ADDENDUM No. 1

DATE: November 22, 2024

PROJECT: Village of Algonquin
Braewood Pump Station Rehabilitation

TAI PROJECT NUMBER: ALG-037

One-Line Diagram
N.T.S.

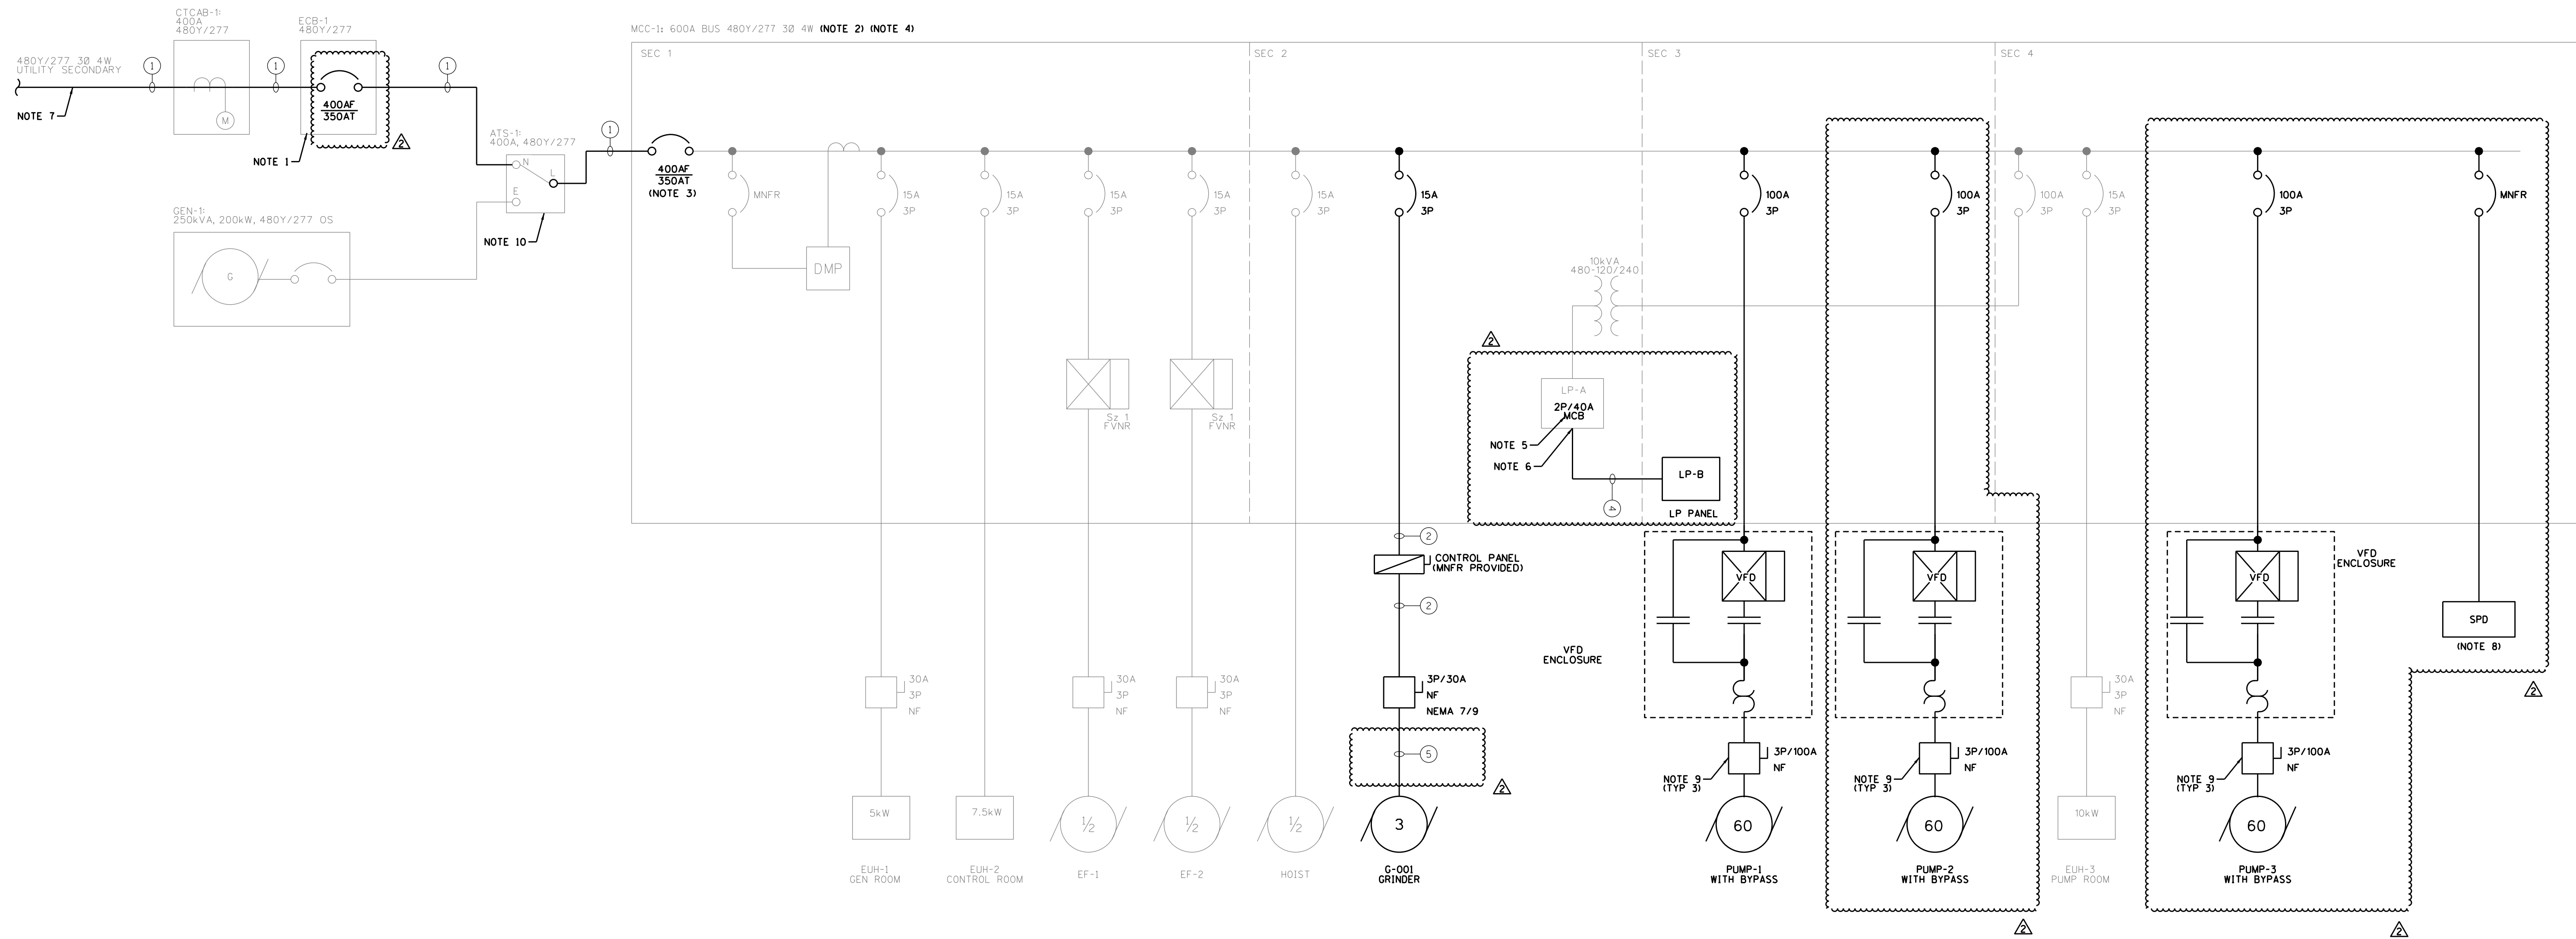
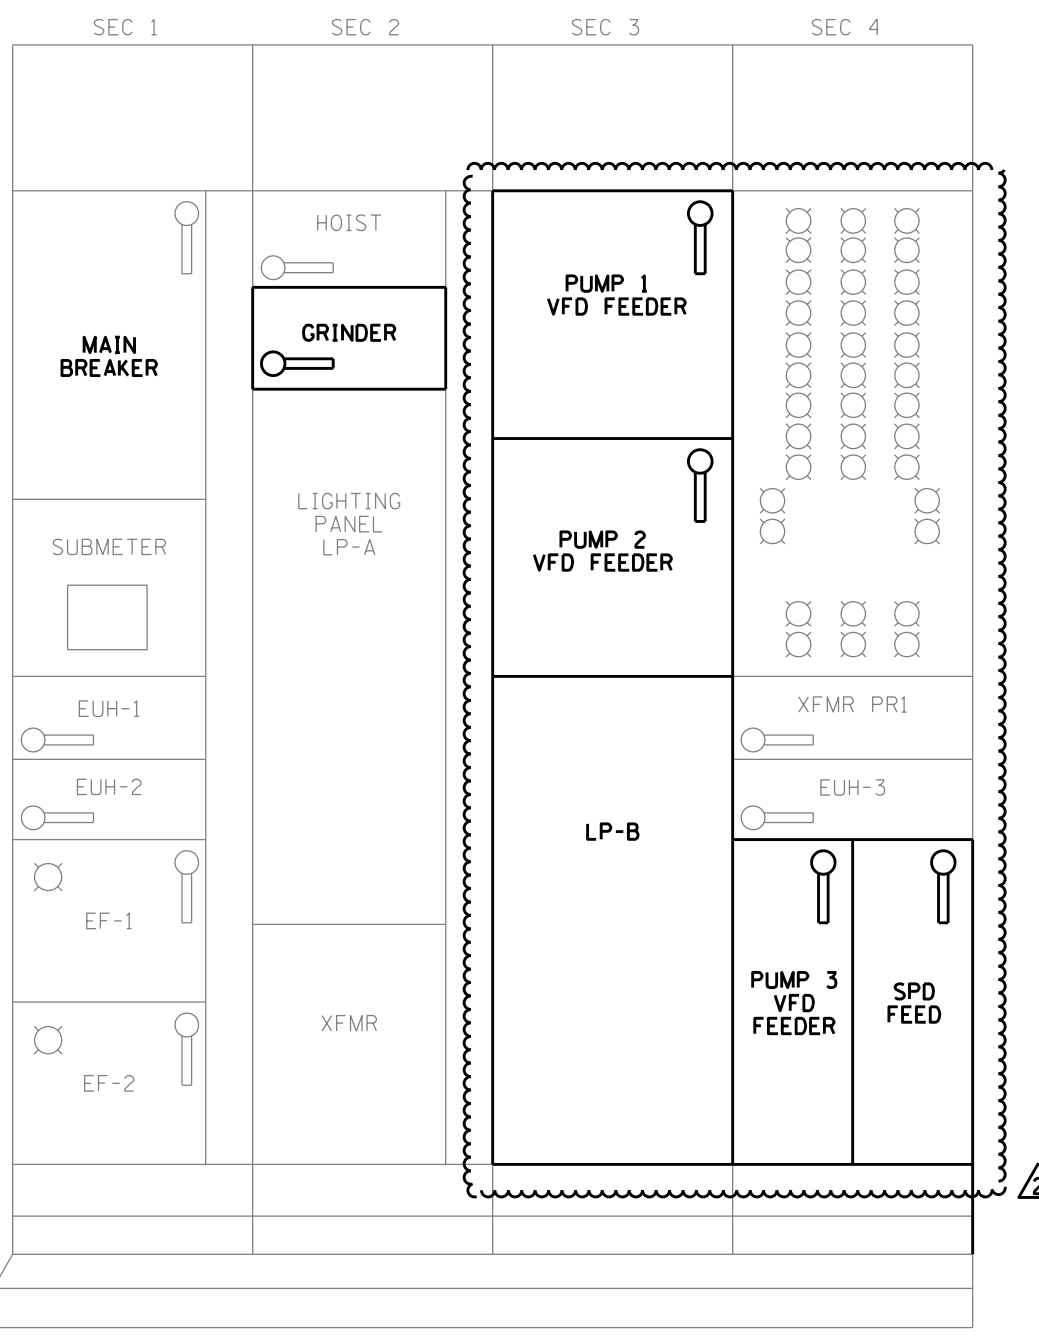
13. Sheet E.3 – Electrical Single Line and MCC Elevation

- A. MCC single-line updated.
- B. Freestanding VFD/bypass packages added (in lieu of new MCC structures shown in bid set)
- C. Various markups for consistency/clarity.
- D. New panel LP-B now integrated into MCC.
